ARMSTRONG SUBDIVISION

APPLICATION NUMBER Holdover DATE January 18, 2007

REQUEST Subdivision

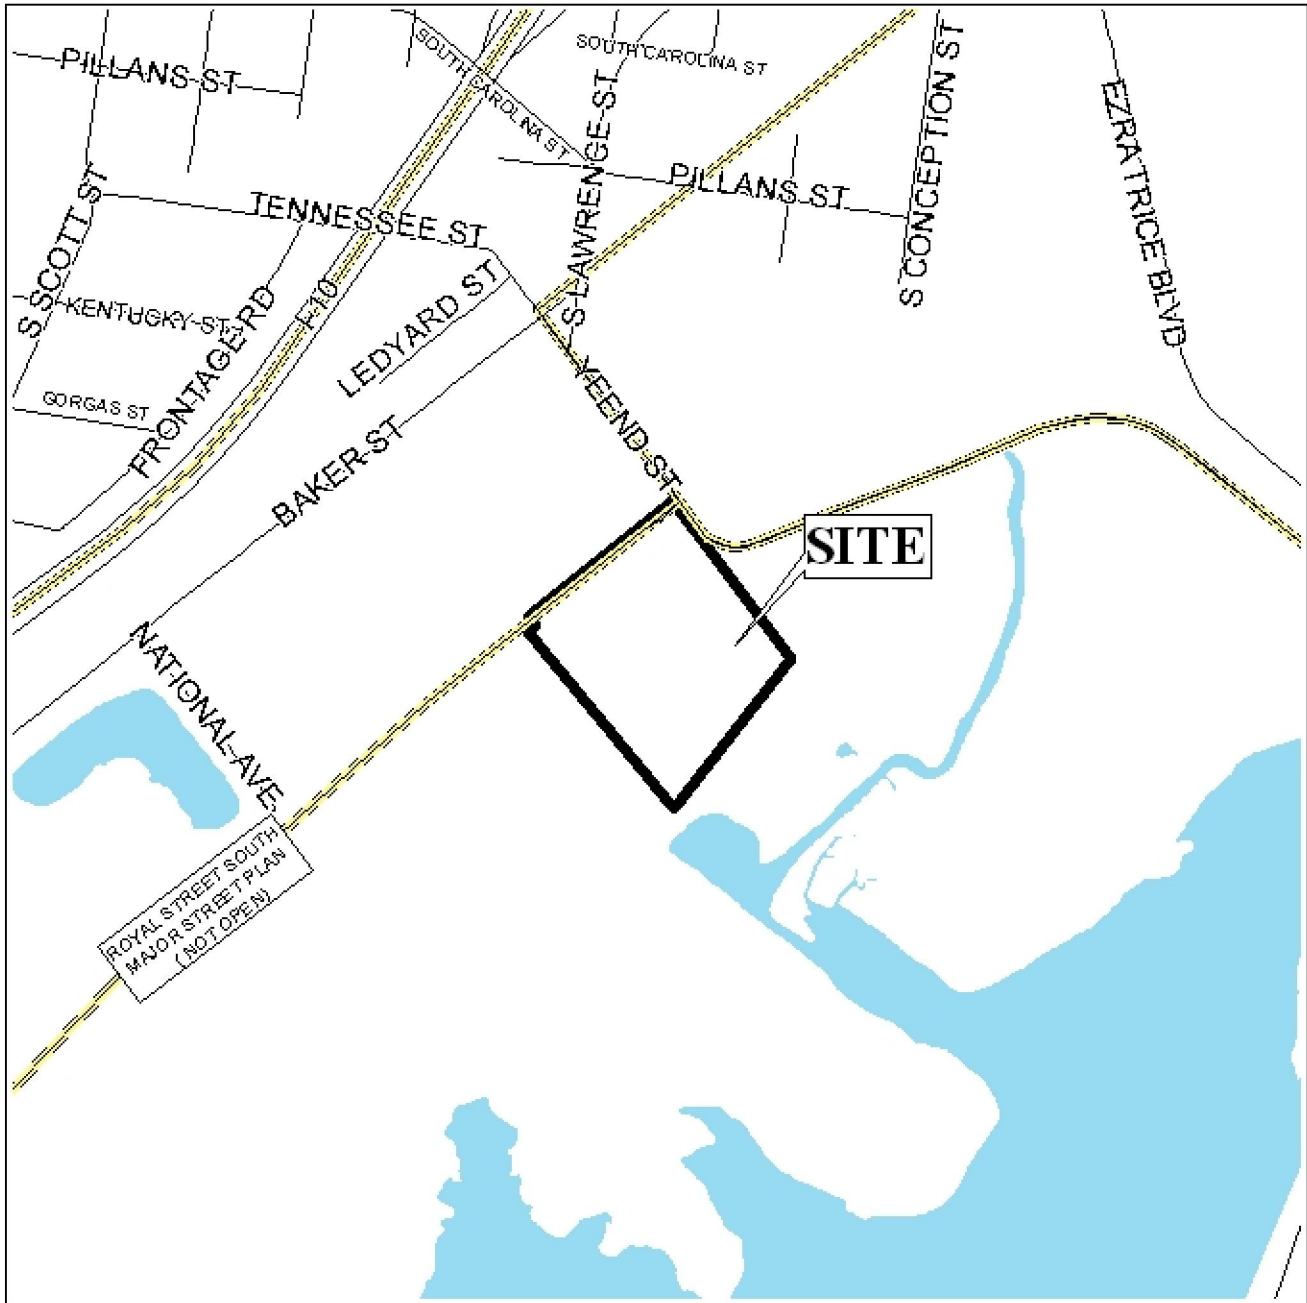
Engineering Comments: Show limit of flood zone/flood way on plat. Show minimum finished floor elevation on each lot. Show any drainage easements. No fill allowed in flood zone without land disturbance permit. The applicant is responsible for verifying if the site contains wetlands. The site can be checked against the National Wetlands Inventory on the COM web site Environmental Viewer. If the site is included on the NWI, it is the applicant's responsibility to confirm or deny the existence of regulatory wetlands. If wetlands are present, no fill allowed without a Corps of Engineers permit. Must comply with all storm water and flood control ordinances. Any work performed in the right of way will require a right of way permit.

Traffic Engineering Comments: Driveway numbers, size, location and design to be approved by Traffic Engineering and conform to AASHTO standards.

While Royal Street Extension is a planned major street, its viability of development to major street standards is questionable. Therefore, in lieu of dedication to provide 50' from centerline, the Commission may consider the placement of additional setback on the plat (75' from centerline) to allow 50' from centerline for the future major street, and the required 25' setback.

The plat meeting the minimum requirements of the Subdivision Regulations and is recommended for Tentative Approval subject to the following conditions: 1) provision of a 75' setback from the centerline of Yeend street to allow for the future major street (50' from centerline for the major street right-of-way and 25' for the required setback); 2) placement of a note on the final plat stating the size, location and design of all curb cuts to be approved by Traffic Engineering and conform to AASHTO standards; and 3) compliance with Engineering Comments (Show limit of flood zone/flood way on plat. Show minimum finished floor elevation on each lot.

Show any drainage easements. No fill allowed in flood zone without land disturbance permit. The applicant is responsible for verifying if the site contains wetlands. The site can be checked against the National Wetlands Inventory on the COM web site Environmental Viewer. If the site is included on the NWI, it is the applicant's responsibility to confirm or deny the existence of regulatory wetlands. If wetlands are present, no fill allowed without a Corps of Engineers permit. Must comply with all storm water and flood control ordinances. Any work performed in the right of way will require a right of way permit).
